Manual to upgrade KARABAS rev.B1 PCB to work with 1024kB RAM Extension PCB:

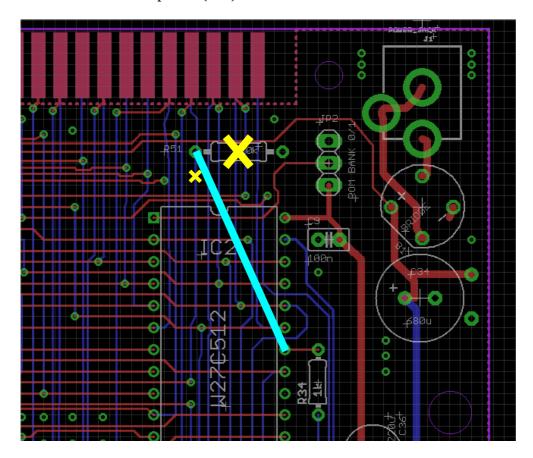
1) free signal VIDEO_VSYNC (PIN_96 Altera), PAL coder VS signal (P15) short to VCC (P14):

2) free signal VIDEO_SYNC (PIN_98 Altera), re-route sync signal from VIDEO_HSYNC (PIN_94 Altera) to the Q5 base instead of VIDEO_SYNC:

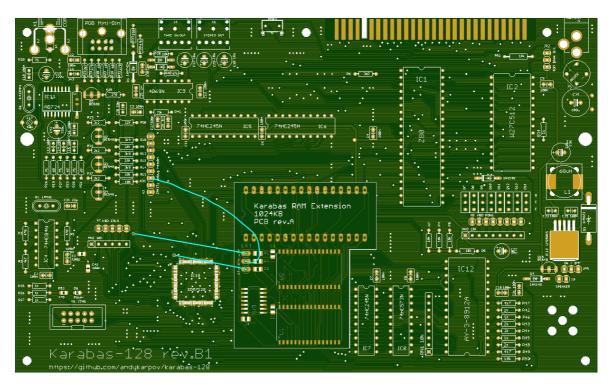
3) free signal BUS_N_ROMCS (PIN_24 Altera), remove resistor R51, re-route ZX BUS signal BUS_N_ROMCS to the ROM's pin 22 (IC2):
